HISTORIC DISTRICT COMMISSION ADDITIONAL INFORMATION REQUEST

Application Number: HDC2026-00456

PROJECT ADDRESS: 1152 Vinewood St

HISTORIC COMMISSION SUBMITTAL
SIDE ELEVATION (REAR PORTION)
EXISTING AND PROPOSED

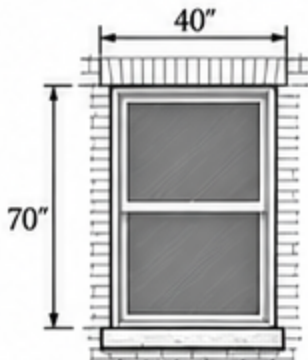
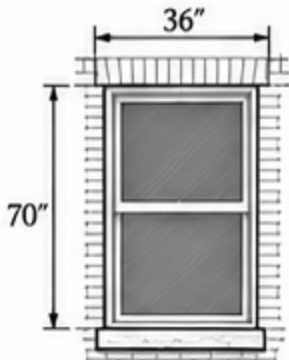
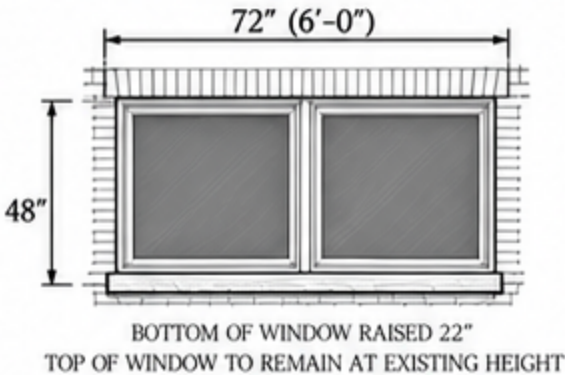
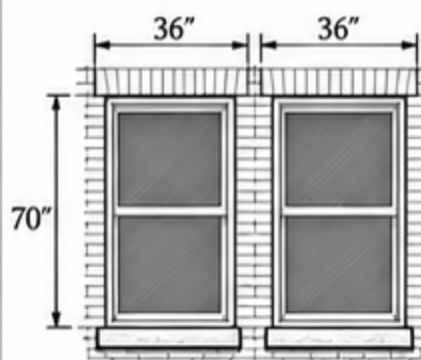
1. Replacing glass pane on 4 windows and/or storm windows. Please note this is considered ordinary maintenance and may proceed without approval.
2. On the first floor side elevation - alter two (2) window opening into a single opening. If so, please verify the size of the existing window openings and the size of the proposed single opening. Please also include an elevation drawing showing the existing and proposed window opening(s).
3. Replace two (2) windows at the rear of the house with wood double hung windows. The size to fit the existing window opening. If so we will need a zoomed out photo of the rear of the house, highlighting the windows in question.

This is the architectural drawing showing the current and proposed changes to the side elevation of 1152 Vinewood. The two windows at the rear (left) end of the home will be combined to make one French casement window that is smaller in height and overall width. This is necessary to allow for cabinet installation in the kitchen. The original windows were only around 2' from the floor making the wall unusable for cabinet installation on the one and only contiguous wall in the space. There are 5 other door and window openings in the space making it highly dysfunctional for modern living.

The windows will be replaced with a wood Anderson French casement window that opens to the exterior.

1. Drawings based on field measurements and owner-provided information.
2. Existing Window A: 40" wide x 70" tall (to be removed).
3. Existing Window B: 36" wide x 70" tall (to be removed and shifted left).
4. Proposed new opening: 72" (6'-0") wide x 48" tall.
5. New window to be a single French casement with two equal 36" wide operable sashes, opening to exterior.

6. Top of new window to remain at existing height, aligned with tops of adjacent first-floor windows.
7. Bottom of new window to be raised 22" from existing.
8. Bricks removed from shifting Window B to the left will be repurposed and integrated into the new design to create a seamless historic ~~rear~~ appearance.
9. Existing two-window set (36" + 36") and three-window set (24" + 48" + 24") to remain as existing. No other openings on this elevation are affected.
10. No new windows proposed on this elevation other than noted.
